DESIGN KE	DRAWN BY RF	DART AEROSPACE LTD HAWKESBURY, ONTARIO, CANADA	
CHECKED KE	APPROVED H	DRAWING NO. DSI 9154	REV. A SHEET 1 OF 1
DATE 99.06.28		TITLE 350 BASKET	SCALE NTS
A	99.06.28	NEW ISSUE (TSR A1207)

## DART SERVICE INSTRUCTION

TO AMEND INSTALLATION DRAWING D350-607 REV E

CANADIAN STC: SH94-14  
US FAA STC: SR00213NY

D350-607-041 LH BASKET INSTALLATION

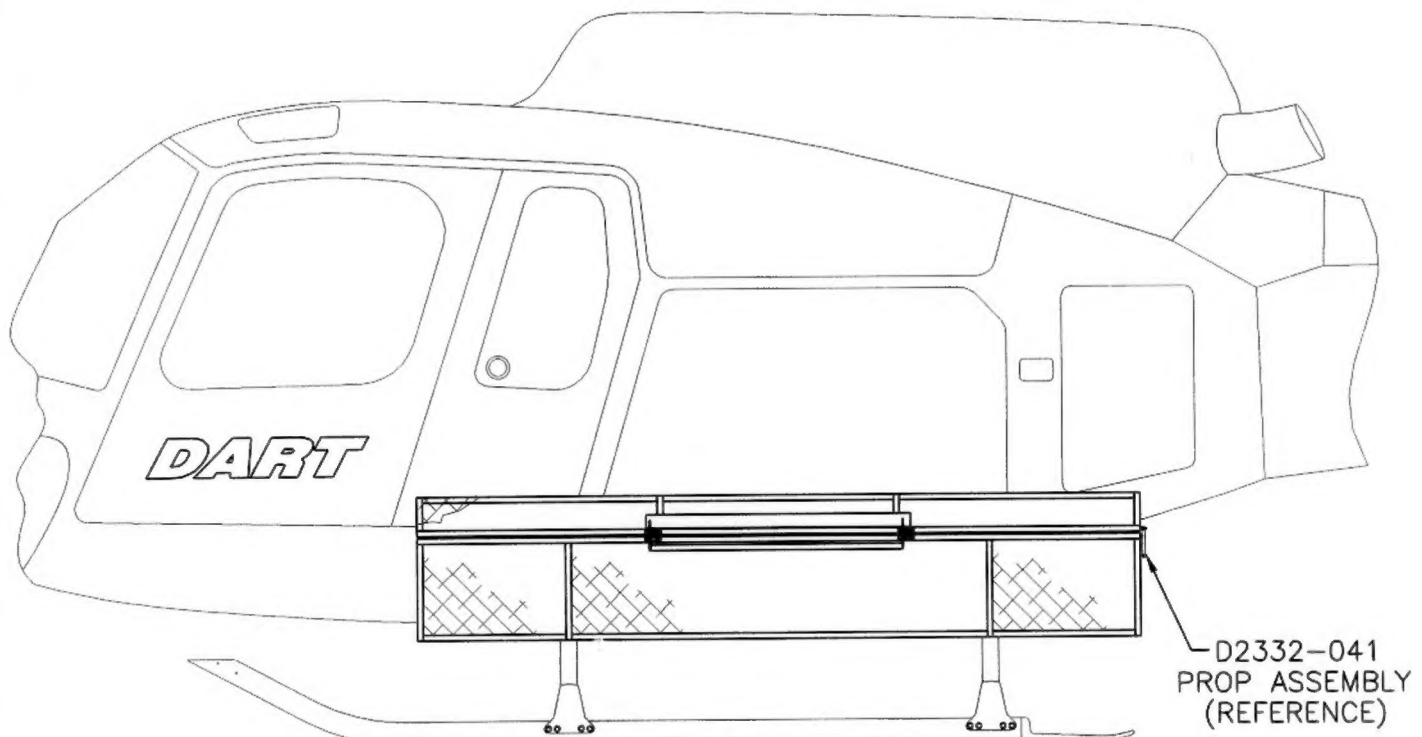
D2332-041 PROP ASSEMBLY OF D350-607-042 RH BASKET CAN OPTIONALLY BE MOVED TO AFT END OF BASKET TO MAKE D350-607-041 LH BASKET. USE EXISTING HARDWARE AND ENSURE NUTS FACE AFT.

NOTE: THE LOCATIONS OF THE FWD AND AFT MOUNTING BRACKETS MAY NEED TO BE SWITCHED TO AGREE WITH INSTALLATION DRAWING D350-607 REV. E.
